The 4K ROM modification.

We now need All on the ROM instead of the RA2 jumper J4.

Mod-1:

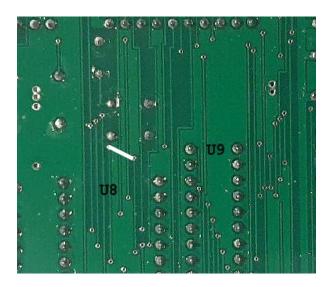
Remove jumper J4 and R12. Connect U8-23 to U9-25.
